ADDENDUM NO. 1

DATE: October 24, 2012

SUBJECT: COUNTY PROJ. NO: 5-41
 STATE PROJECT NO: 019-605-028, 179-020-031, 1901-148
 MINN. PROJECT NO: HPPH-STP09-STP 1912(258)
 LOCATION: TH 13/CSAH 5 Interchange Burnsville
Addendum No. 1
 Date of Letting 9:00 a.m. October 30, 2012

DES: GBB DR: RLV APPROVED: 10/9/12
 CHK: PDG CHK: TRS
 SHEET NO. 33R OF 91 SHEETS

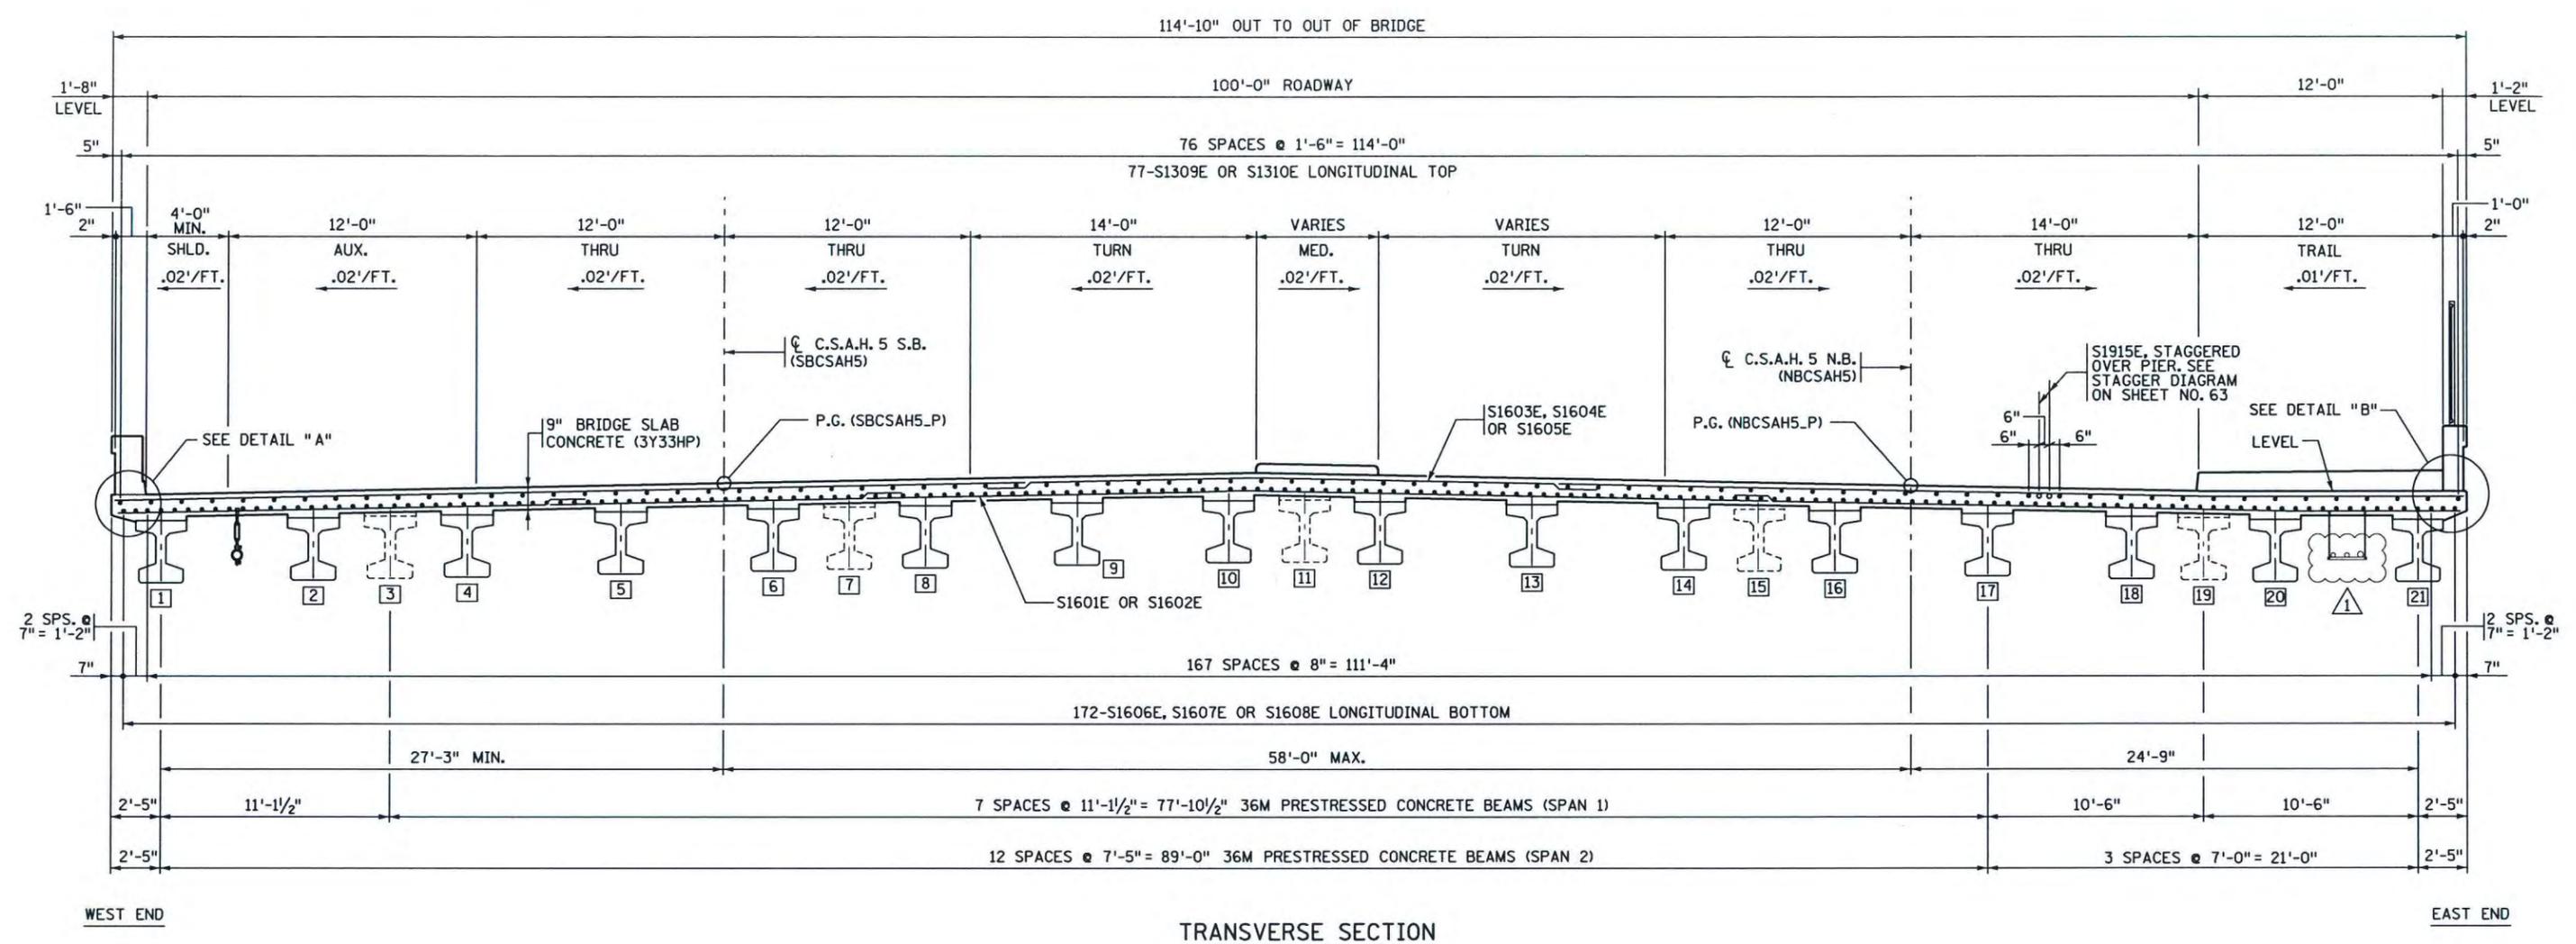
- C. On Sheet 33R of 91 for Bridge No. 19036 the following changes were made:
 - a. The number and configuration of pipe sleeves going through the abutment backwall were modified, as well as circle note 7.

DES: P.D.G. DR: N.A. APPROVED: 10/9/12
 CHK: G.B.B. CHK: T.R.S.
 SHEET NO. 61R OF 91 SHEETS

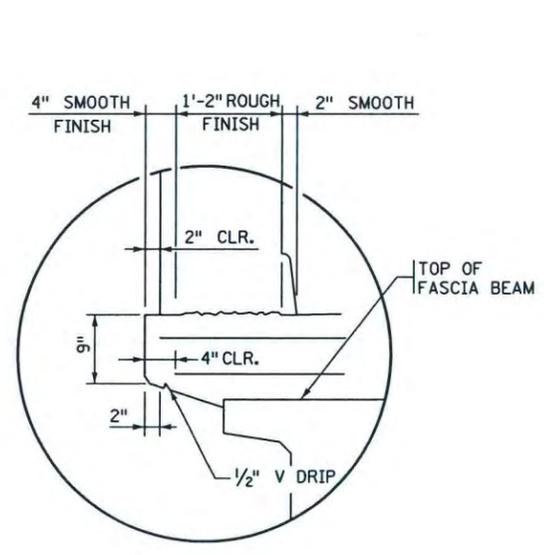
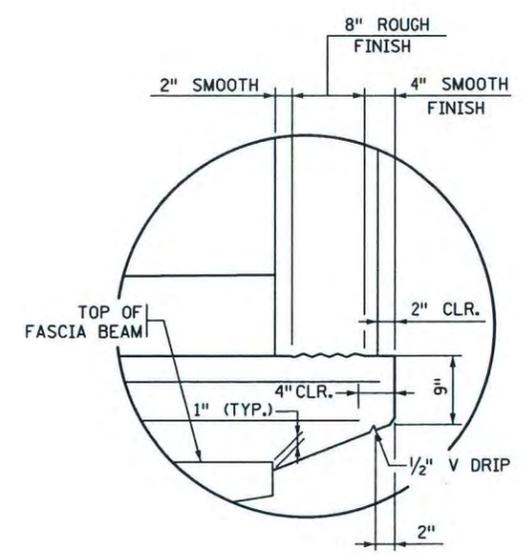
- D. On Sheet 61R of 91 for Bridge No. 19036 the following changes were made:
 - a. The number and configuration of suspended conduits on right side of the "Transverse Section" were modified.

DES: GBB DR: RLV APPROVED: 10/9/12
 CHK: PDG CHK: TRS
 SHEET NO. 74R OF 91 SHEETS

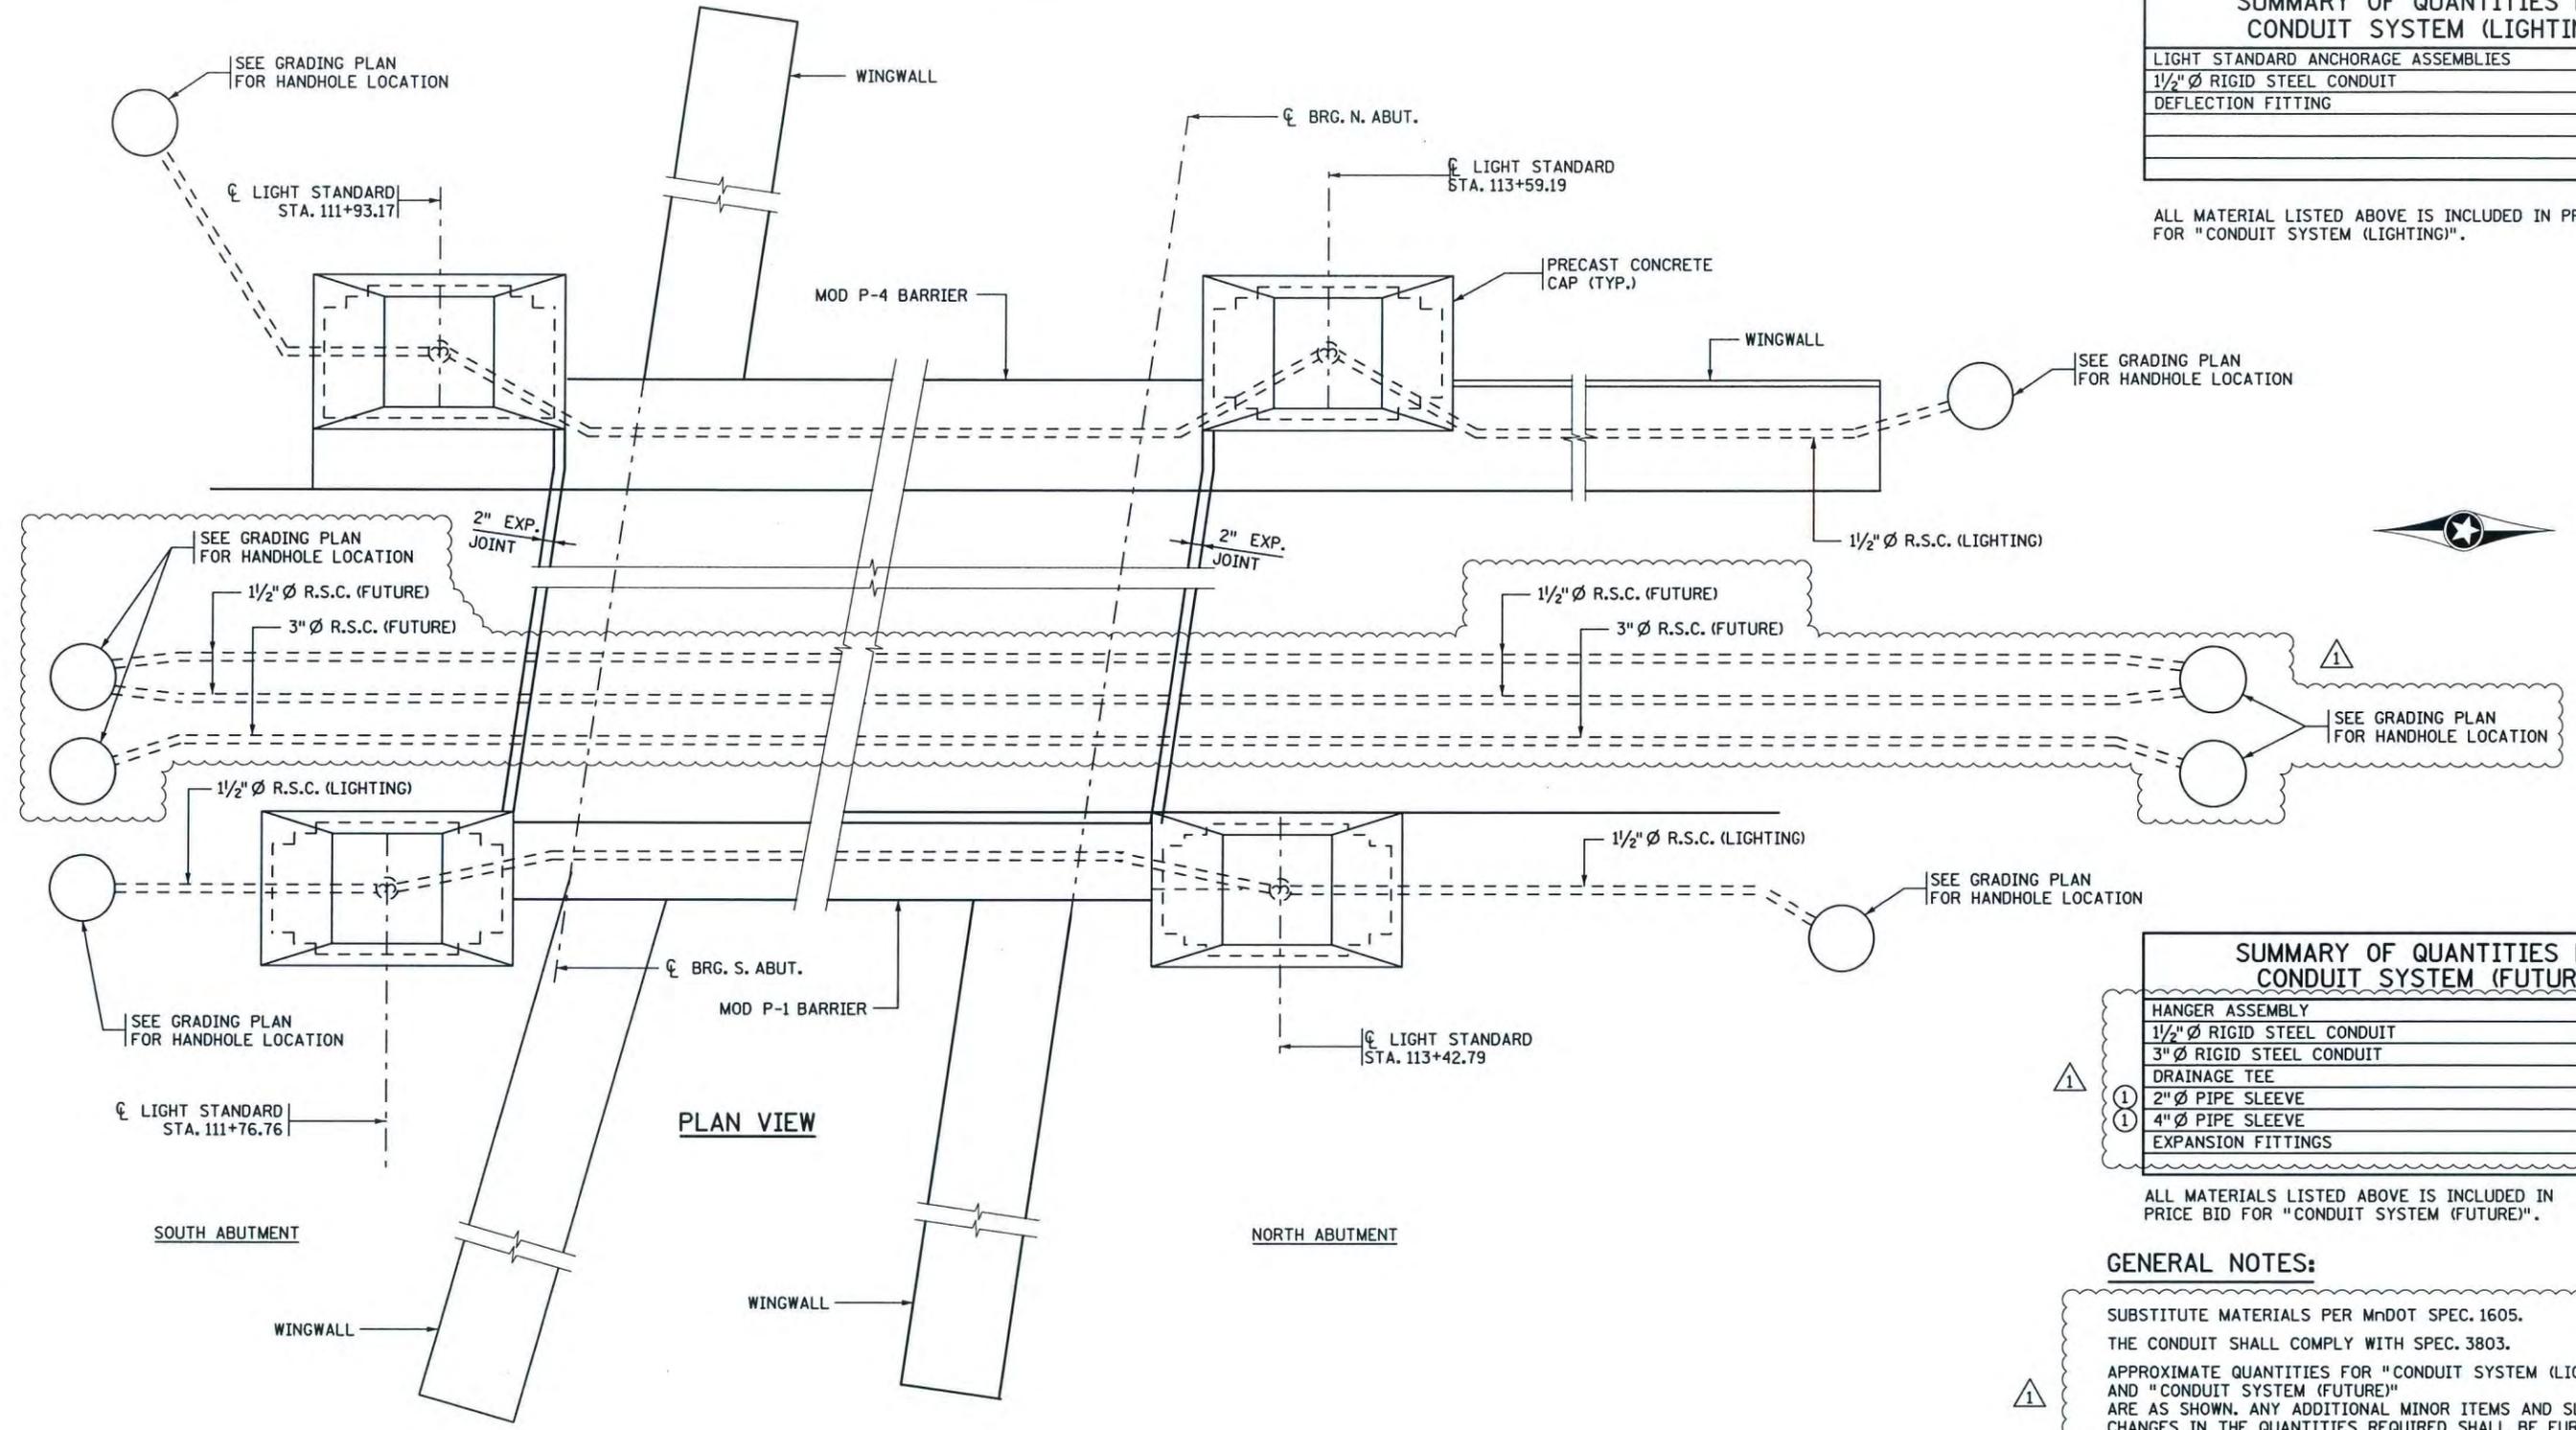
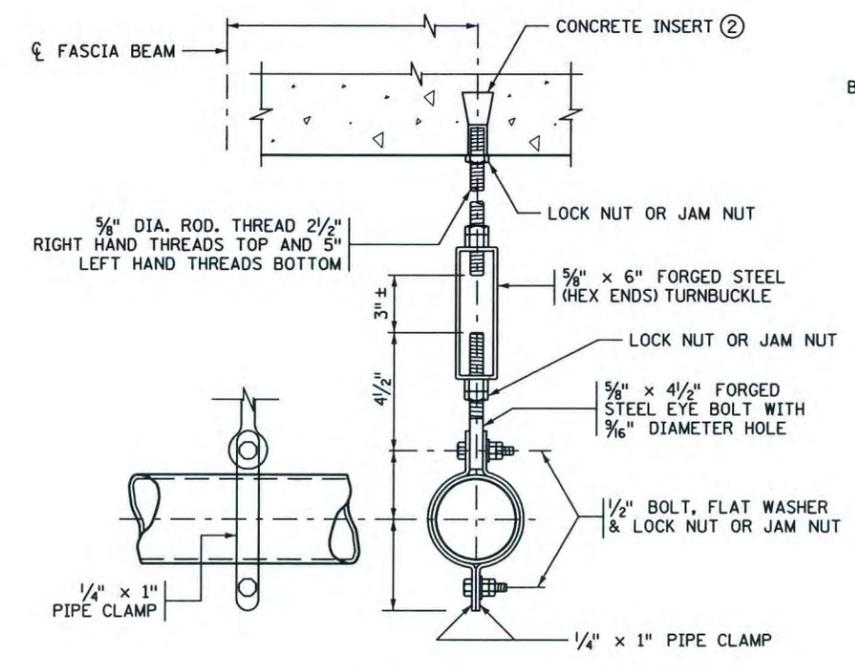
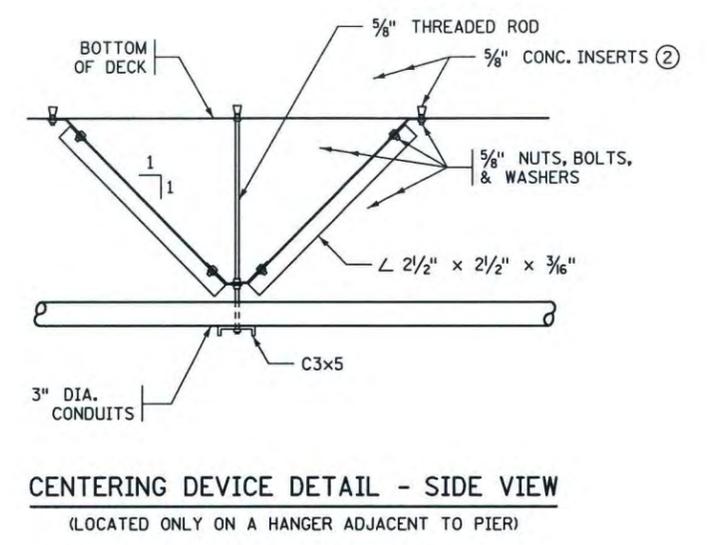
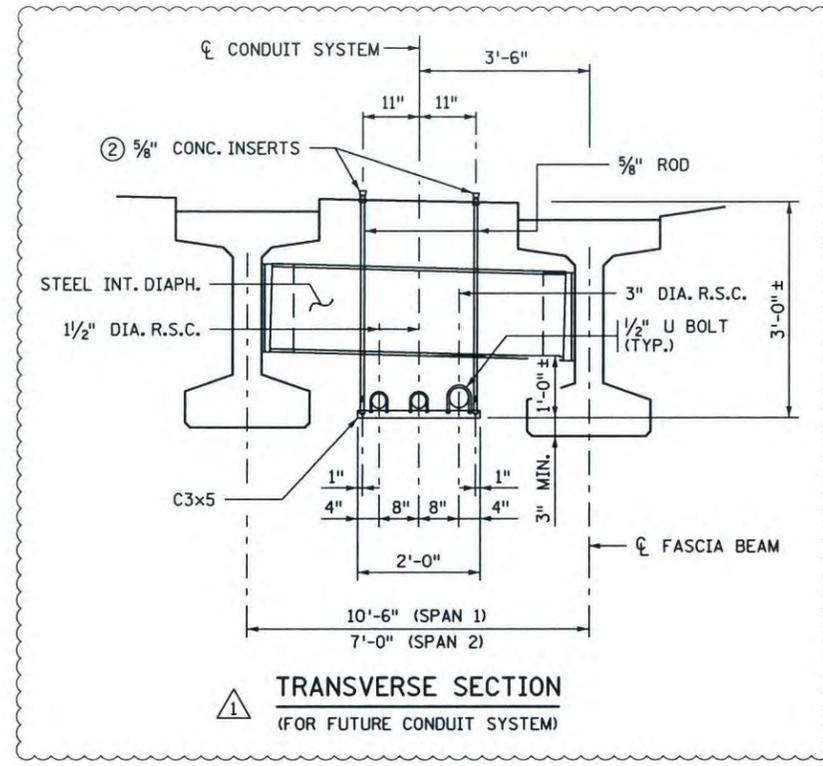
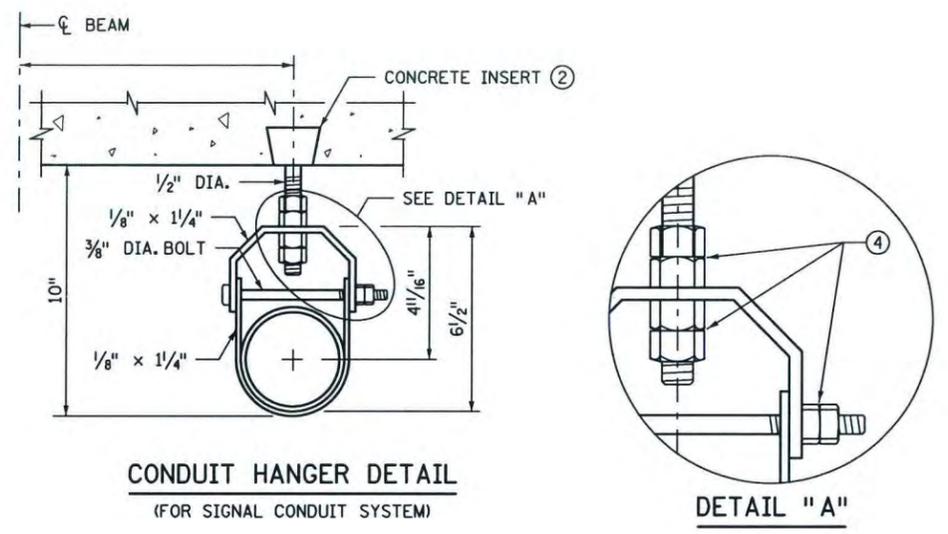
- E. On Sheet 74R of 91 for Bridge No. 19036 the following changes were made:
 - a. The number and size of conduits for the "Conduit System (Future)" were modified.

- b. The quantities in the "Summary of Quantities for Conduit System (Future)" were modified.
 - c. Some notes under "General Notes" were eliminated.
- F. On Sheet 76R of 91 for Bridge No. 19036 the following changes were made:

DES: GBB DR: RLV
 CHK: PDG CHK: TRS
 SHEET NO. 76R OF 91 SHEETS
 APPROVED: 10/9/12
 BRIDGE NO. 19036

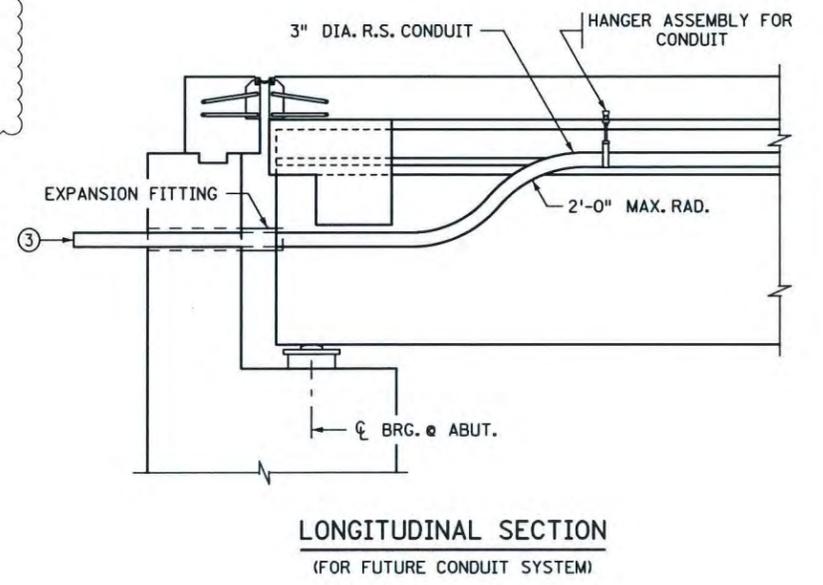
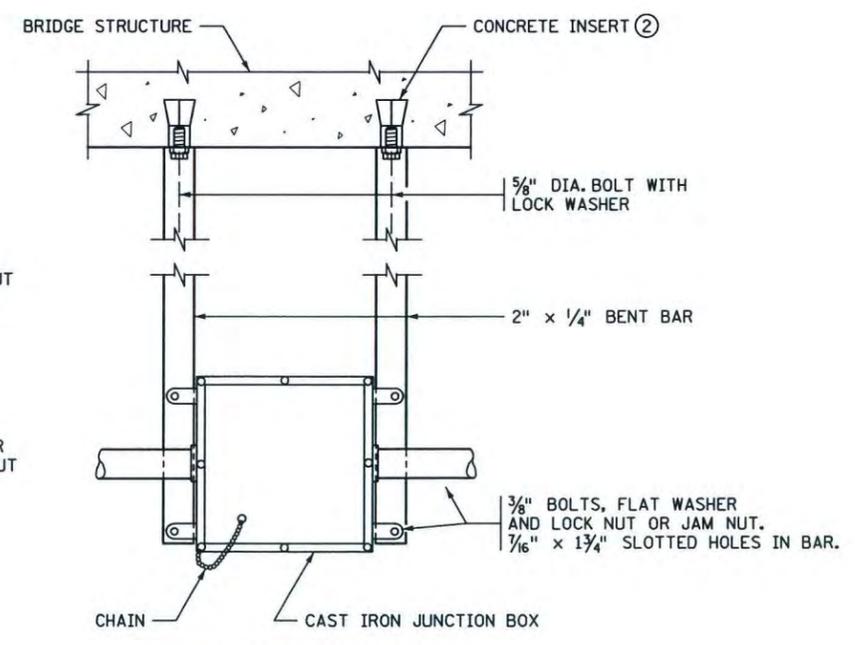
- a. The overall configuration of the "Transverse Section", including the number and size of conduits, was modified.
